MIL-PRF-19500/684
AMENDMENT 1
7 June 2001

PERFORMANCE SPECIFICATION

SEMICONDUCTOR DEVICE, TRANSISTOR, FIELD EFFECT, SILICON, N-CHANNEL,
RADIATION HARDENED (TOTAL DOSE AND SINGLE EVENT EFFECTS)
TYPES 2N7472U2, 2N7473U2 AND 2N7474U2
JANTXVR AND JANSR

FIGURE 3. Safe operating area graph."

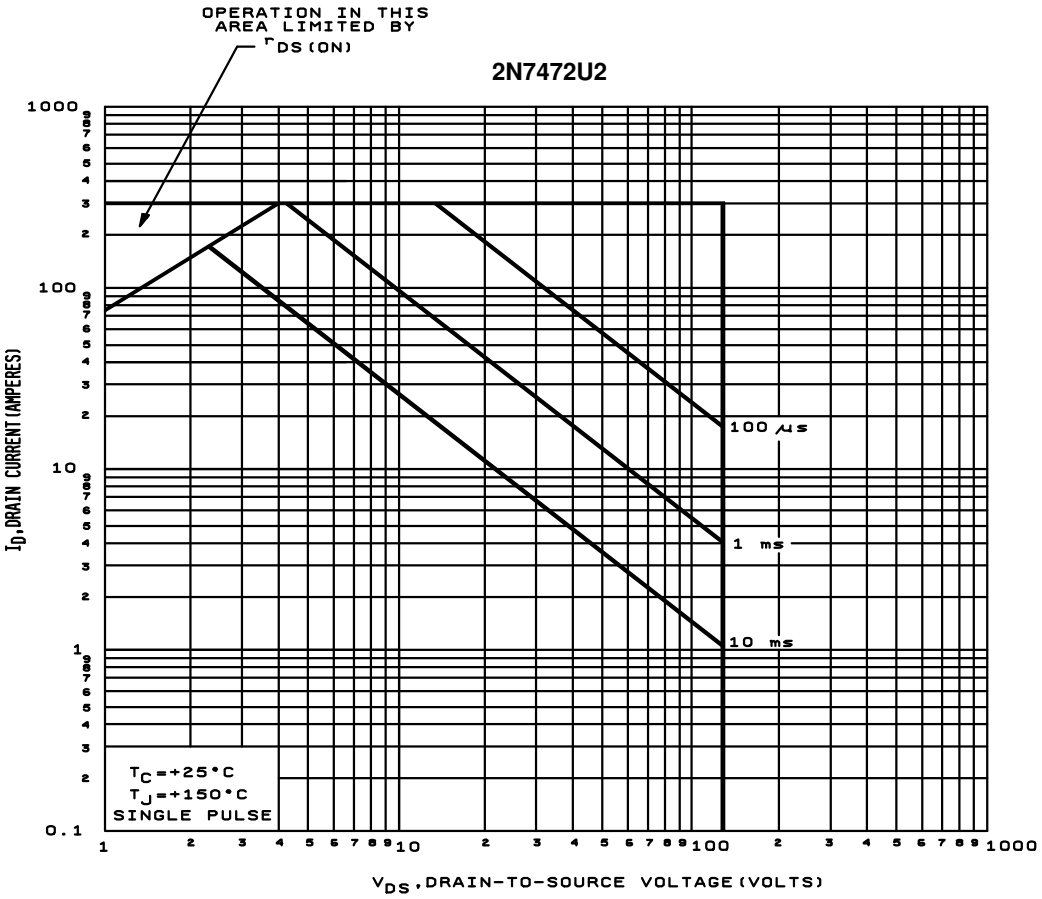
FIGURE 3, delete and substitute:

FIGURE 4. Safe operating area graph."

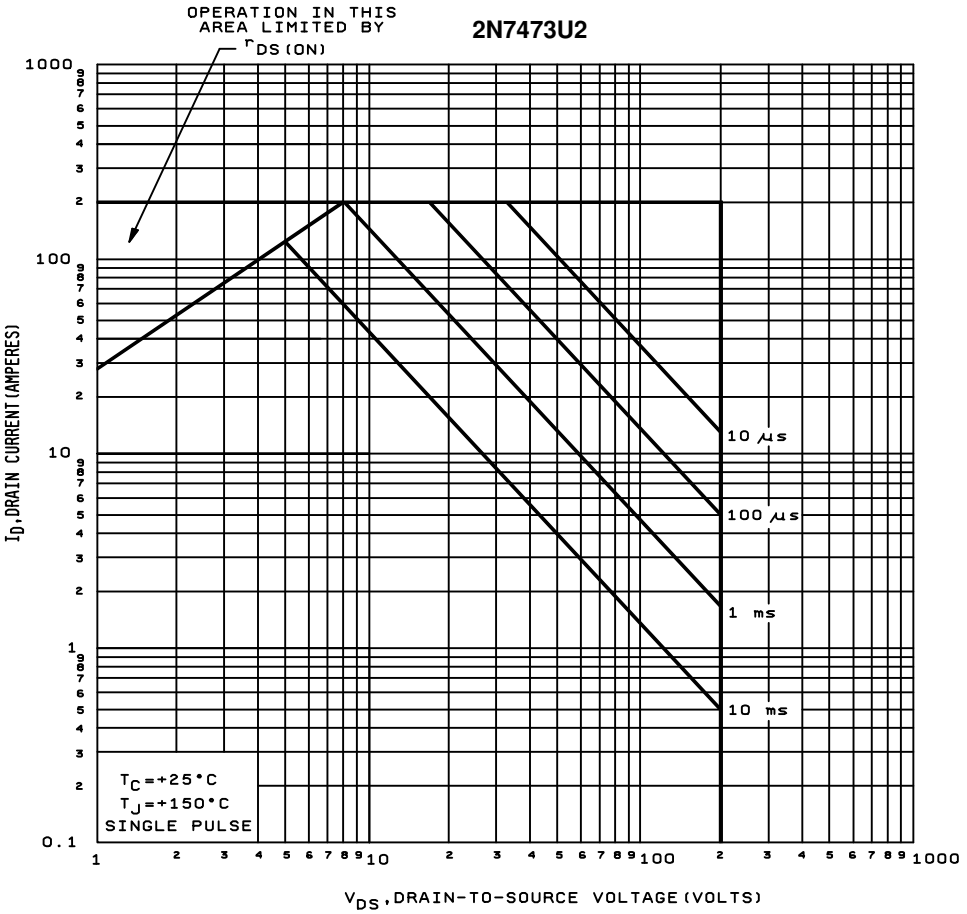
FIGURE 4, delete and substitute:

FIGURE 5. Safe operating area graph."

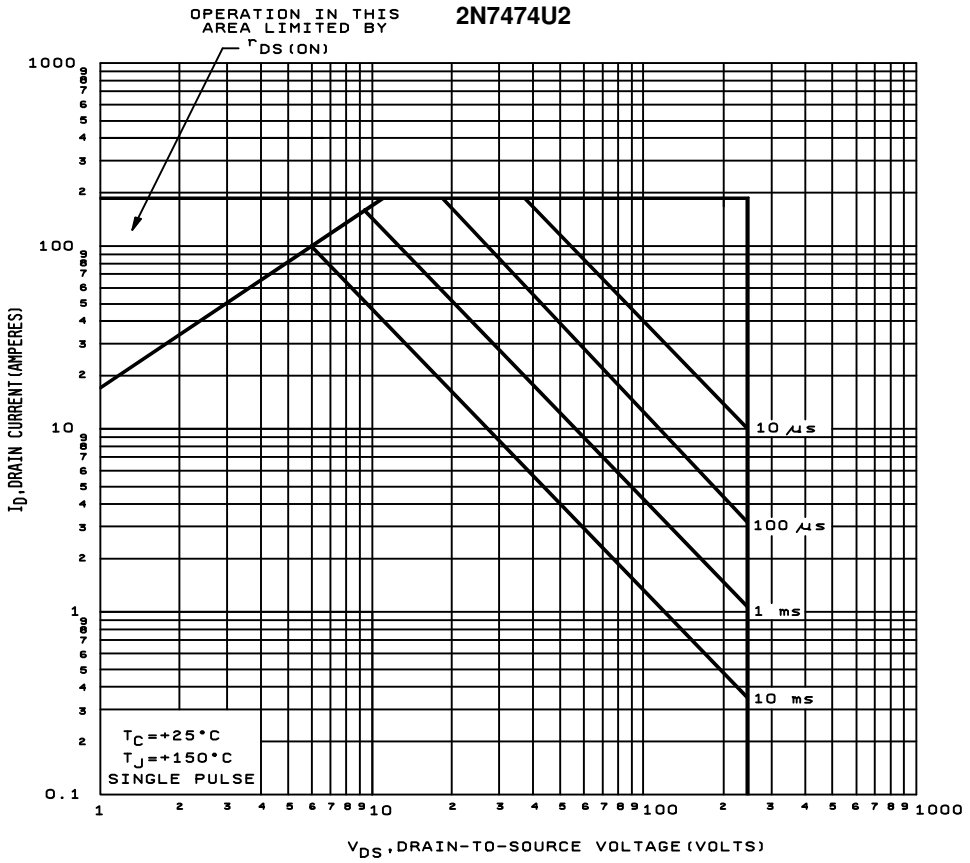
FIGURE 5, delete and substitute:
